Mr. Dennis Gourde, P.Eng.  
General Manager  
Agnico – Eagle Meadowbank Division  
Baker Lake Office

**Report No 7  
Meadowbank Mine Dike Review Board  
Meeting July 26-29, 2010**

The objectives were to review the status of the performance of the East Dike, and the design and construction of the Bay-Goose and TSF dikes.

**MEADOWBANK GOLD PROJECT - BAY-GOOSE DIKE**  
**SAMPLES FROM STOCKPILE OF FINE CRUSHED STONE**  
**GRAIN SIZE CURVES**

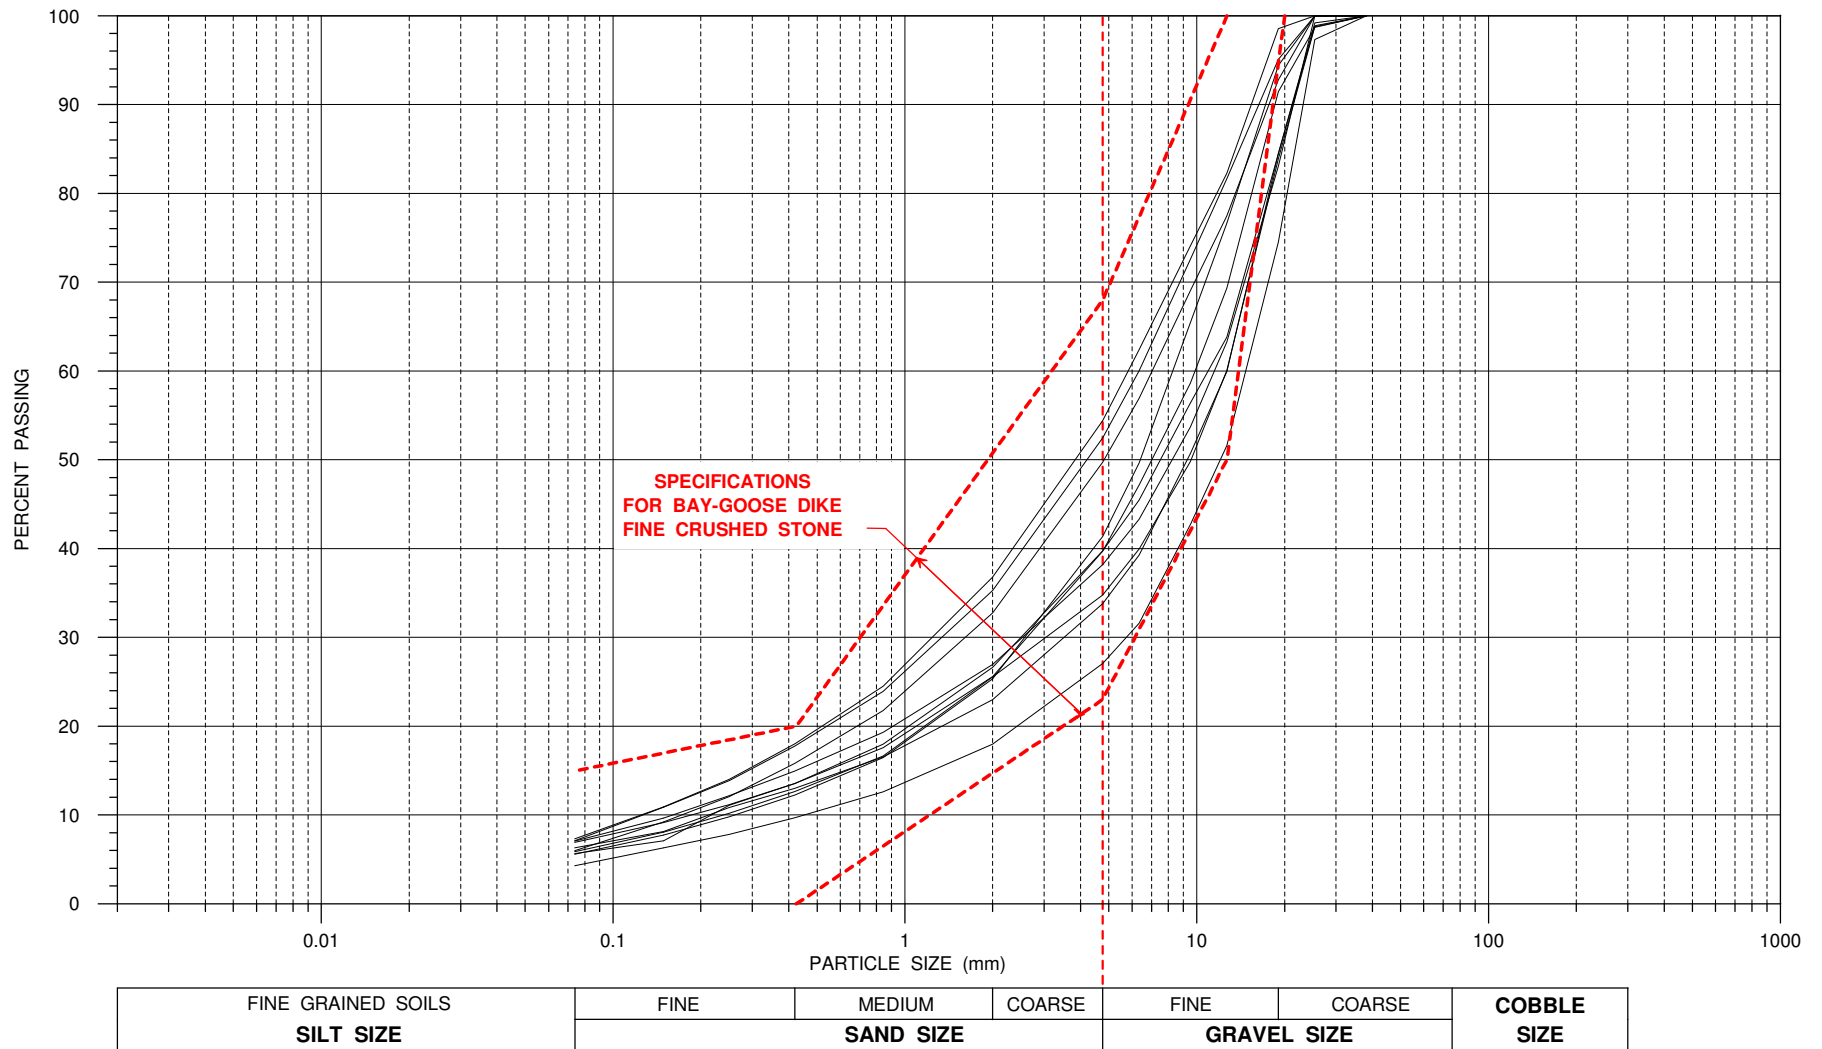
Observations made during the site visit included the Soil-Bentonite (SB) fill preparation (photo # 7); embankment widening, functioning of turbidity barriers, water pumping to assist containment; central trench excavation, fine filter material stockpiles for the Bay Goose Dike. The Board was pleased to see how effective the turbidity barriers, together with the causeway, have been in controlling suspended sediment migration. The stockpile of fine filter material was examined and the Board remarked on the apparent high fines content (photo # 8). This non-PAG material is produced from relatively friable volcanic rock and the crushing and handling may generate

excessive fines. However, the grain size analyses, transmitted subsequent to the Board meeting and shown in Appendix C, indicate the material to be well graded and within the specified envelope except for a small fraction of oversize particles. As the materials were dry when observed it is possible that some segregation on the outer slopes of the piles may have contributed to the perception of a less well graded product. Nevertheless, it is evident that care is required in the exploitation of the stockpiles, particularly when dry, in order to minimize the segregation.

**MEADOWBANK GOLD PROJECT - STORMWATER DIKE**

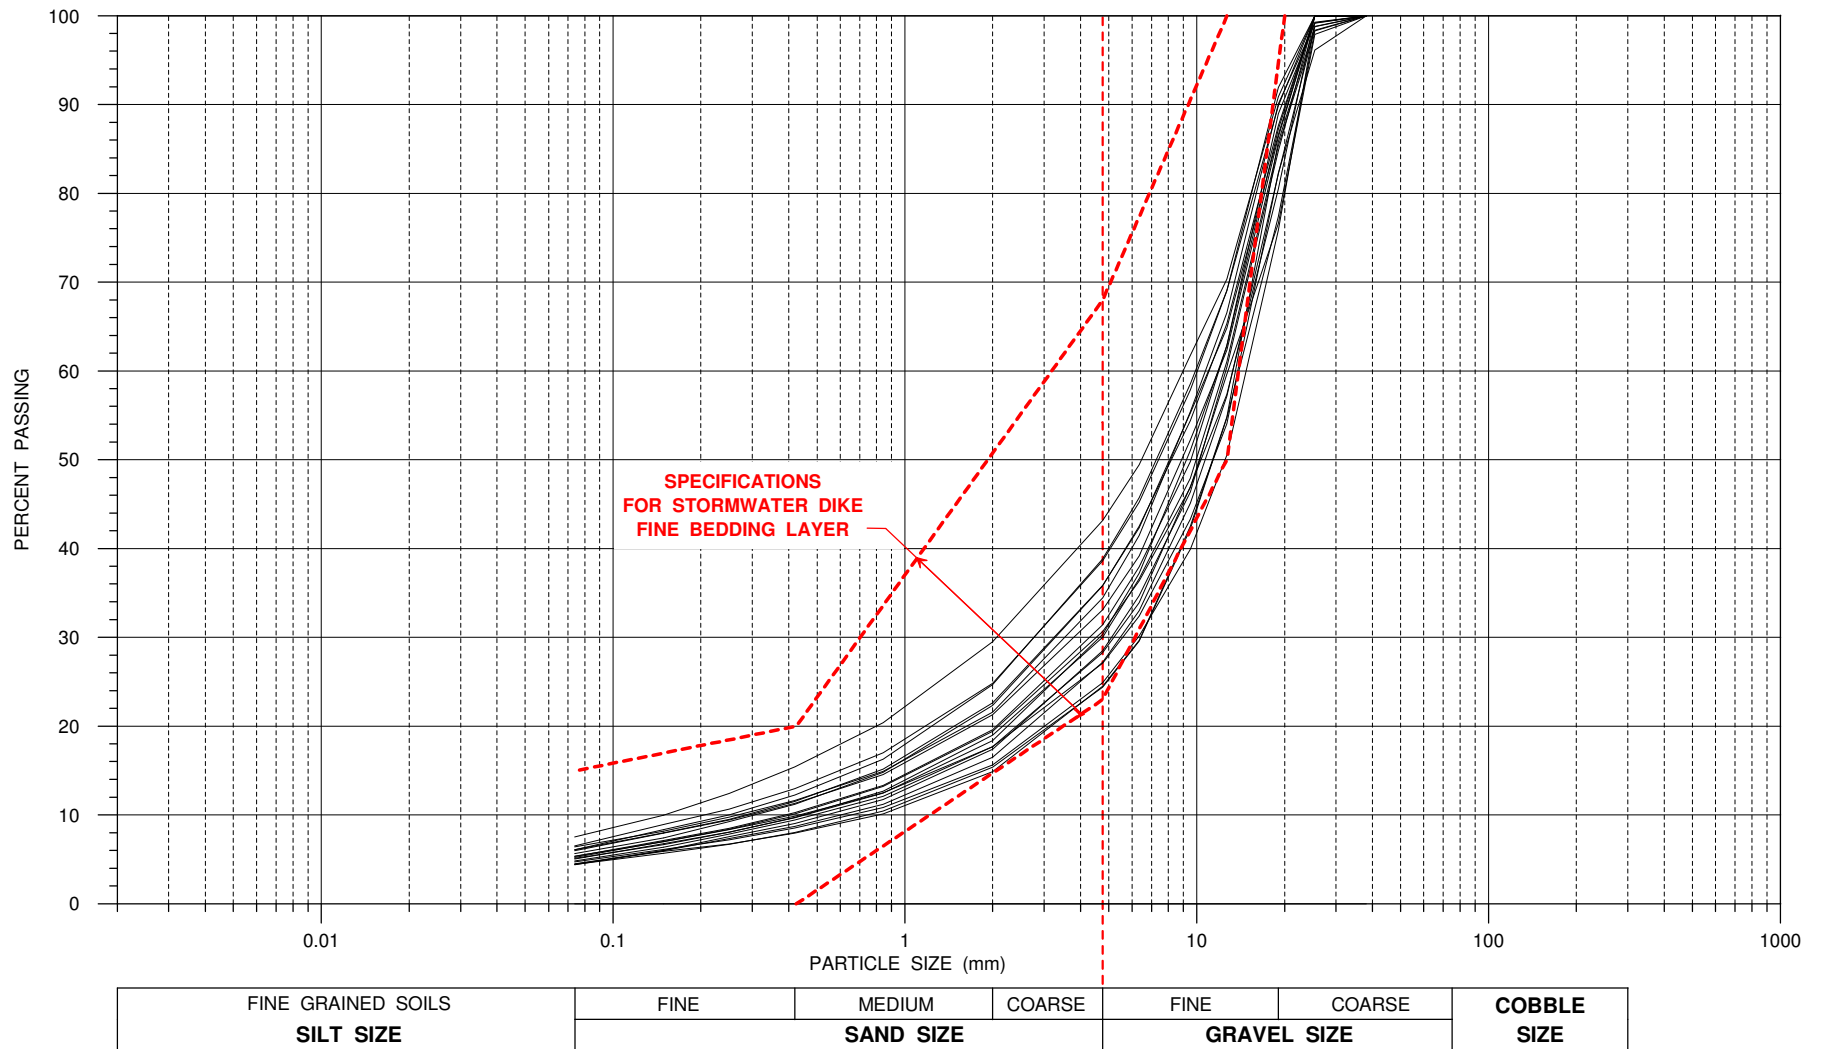
The Board paid a visit to the Stormwater Dyke and inspected the bedding material (photos # 9 and 10), the liner as placed and welded (photos # 11 to 13), though there was no ongoing activity, and the tailings beach (photo # 14). The susceptibility of the liner to damage by construction and operation equipment was noted. The standard of placing is variable and this is apparently due to weather conditions (wind etc) prevailing at the time of installation.
